MEMORANDUM

DEPARTMENT OF NATURAL RESOURCES DIVISION OF GEOLOGICAL AND GEOPHYSICAL SURVEYS

SUBJECT: Chilkat River (Schnabel Fill & Culvert Installation) hazard area designation

Figure1. Location of proposed materials site in relation to designated slope hazard areas of the Haines Coastal Management Plan. Red line is Management Area boundary, yellow shading is designated slope hazard area. Source: Haines Coastal Management Plan (2007).

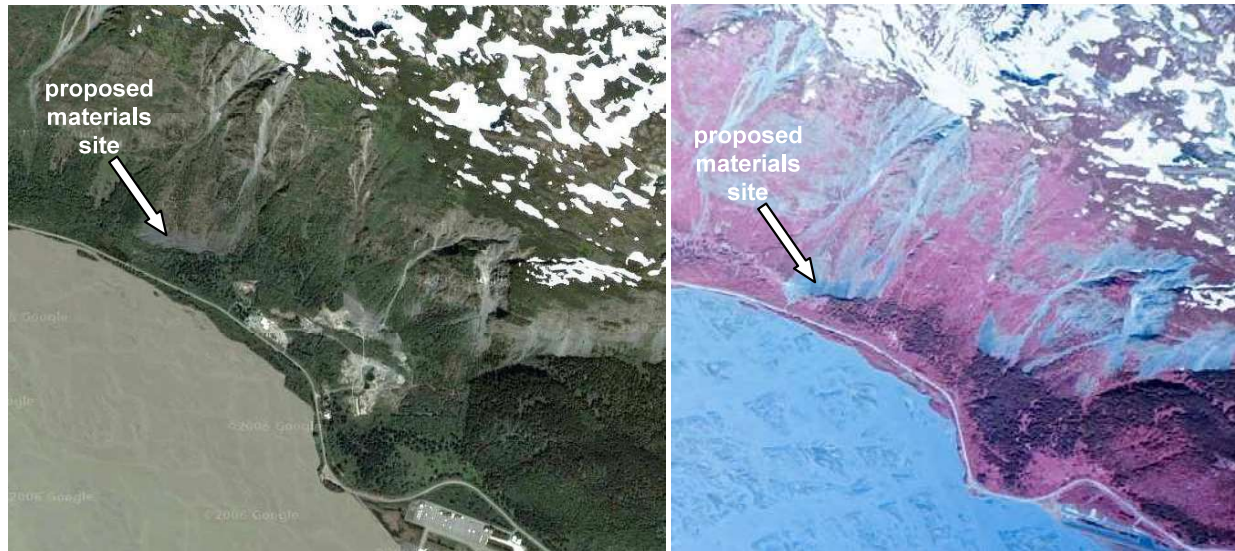
2. The proposed materials site is approximately 1 mile outside the boundary of the Haines Coastal Management Area and slope conditions are equivalent to or more extreme than those comprising designated slope hazard areas within the management area (fig. 1). The Haines Coastal Management Plan (2007) notes that small landslide and snow avalanche debris accumulations occur along the steep mountain front north and northwest of Haines and along the fjord walls of the Chilkoot and Lutak inlets. The Plan (2007) goes on to point out that numerous landslides of considerable extent occur frequently in the Haines borough, and that a landslide in the late 1890's virtually destroyed a Native village at 19-mile Haines Highway.
